Savannah Homes Inc. (Silver Leaf PUD) - 5100 NE 38th Avenue

APPROVAL of a request from Savannah Homes, Inc. (purchaser) represented by Ted Grob (officer) to amend the Des Moines 2020 Community Character Plan to designate the property located in the vicinity of 5100 NE 38th Avenue as Low Density Residential and as Low/Medium Density Residential as more specifically shown on the accompanying map. The subject property is owned by Central Iowa Developers, L.C. (21-2007-4.08)

By same motion and vote, members recommended **APPROVAL** of a request to rezone approximately 37 acres of agricultural land located in the vicinity of 5100 NE 38th Avenue from "A-1" Agricultural District to "PUD" Planned Unit Development District, and for approval of a PUD Conceptual Plan titled "Silver Leaf" to allow development of such property with 121 single-family residential lots and 38 bi-attached residential units, subject to the following revisions:

PUD CONCEPTUAL PLAN FOR SILVER LEAF

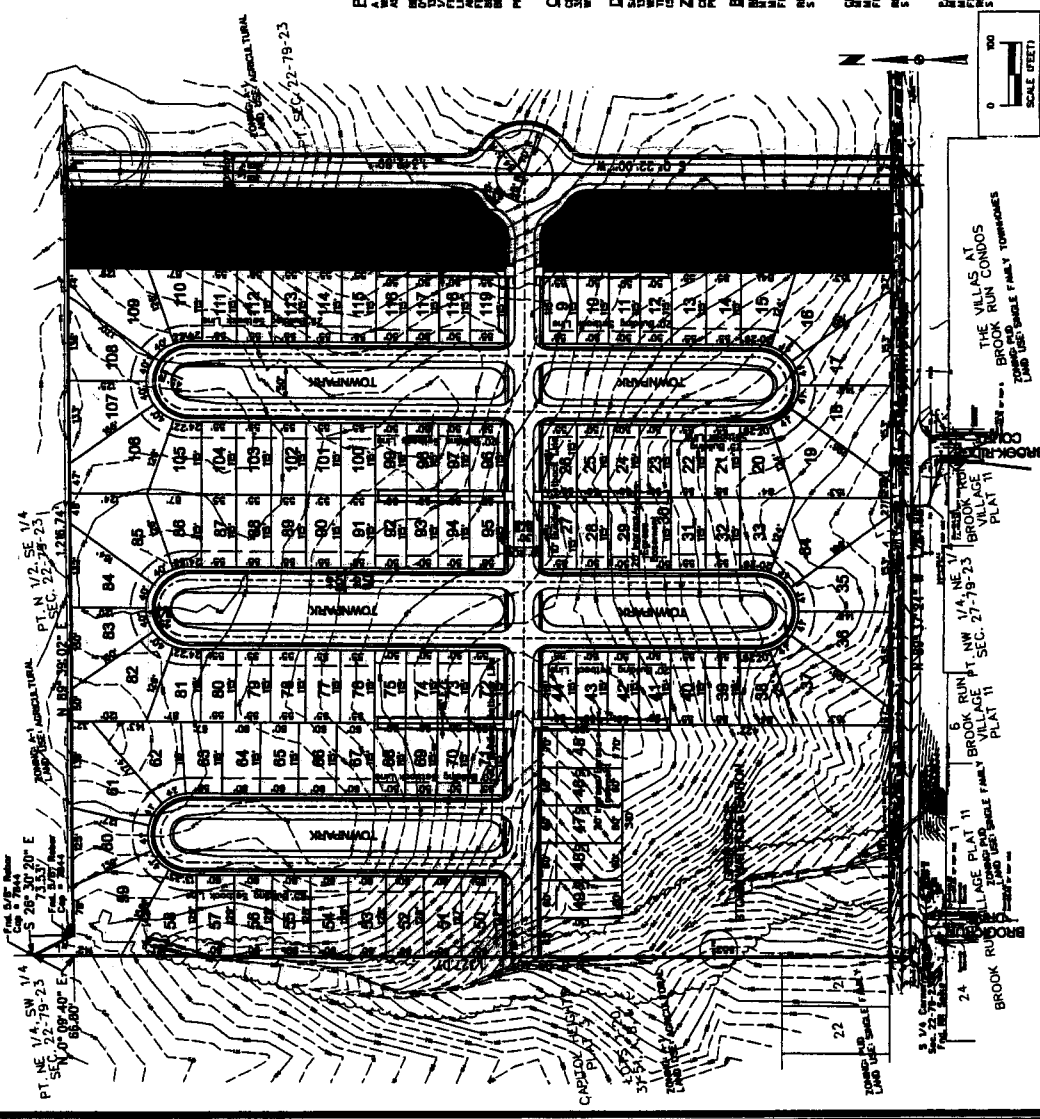
1. Provision of a note stating that a tree protection plan will be submitted as part of any preliminary plat or grading plan and that no trees will be removed from the subject property prior to approval of a tree protection/mitigation plan.

2. Provision of a note stating that analysis by the developer of the town park areas for implementation of conservation storm water management practices will be made as part of any preliminary plat or development plan submitted under the PUD.

3. Addition of a row of over-story trees spaced at a minimum of 50' on center in the south 15' of the PUD along NE 38th Avenue in lieu of required street trees.

4. Provision of a note in the bulk regulations that the porch setback requirements are for open / unenclosed porches only.
5. Provision of a note that prohibits drive access from the public street for those lots served by a common private drive in the rear yards.

6. Provision of a note in the bulk regulations limiting the total amount of attached or detached garage area on rear-loaded lots to a maximum 576 square feet and the total amount of detached garages or accessory structures on all other lots to a maximum 720 square feet.

7. Provision of a temporary turnaround for emergency apparatus on the north end of the north/south collector street.
8. Provision of a 37' flair tapered for 150' on the plan where the north/south collector street intersects with NE 38th Avenue (also known as E. Douglas Avenue).

9. Demonstration of how a second public street connection to NE 38th Avenue would be achieved in the future to accommodate development of land adjoining to the west.

10. Revision of the crescent or looped streets to have a 22' back to back paved width and a minimum 4' wide integrated sidewalk of a design capable of supporting all emergency apparatus in the City inventory or other design acceptable to the Fire Chief and City Engineer.
